NORTH BAY AT LAKE WOODMOOR PUD PRELIMINARY PLAN/PUD SITE PLAN

LETTER OF INTENT

JUNE 2022

Planning Comments V1 - MPF

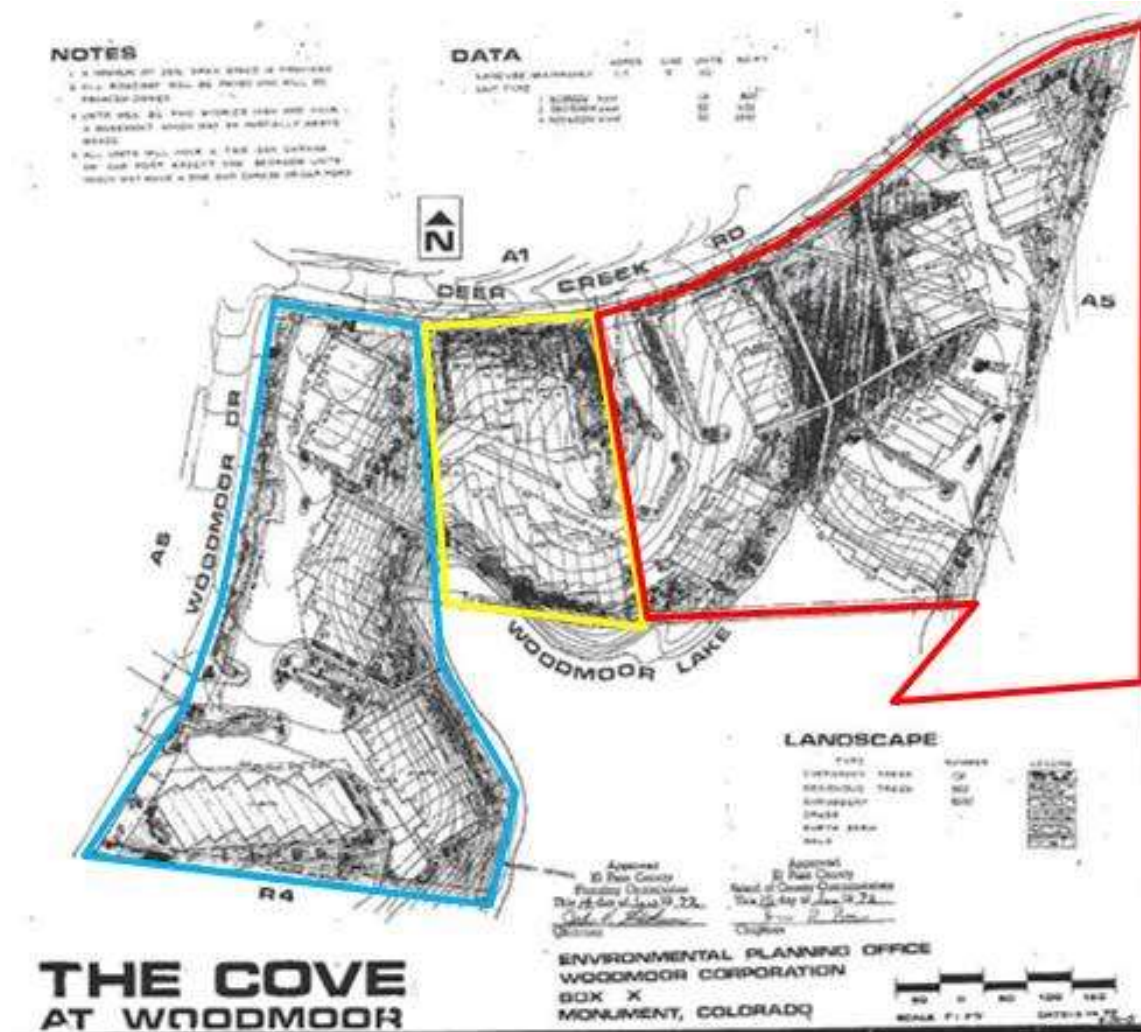
This property is currently zoned PUD. Please update this section to reflect this fact and include the history of the zone change from R-4 to PUD and why the PUD needs to be updated for this new proposal. Please correct in every location on the application where it states that the current zoning is R-4. I believe it is a remnant of the original application.
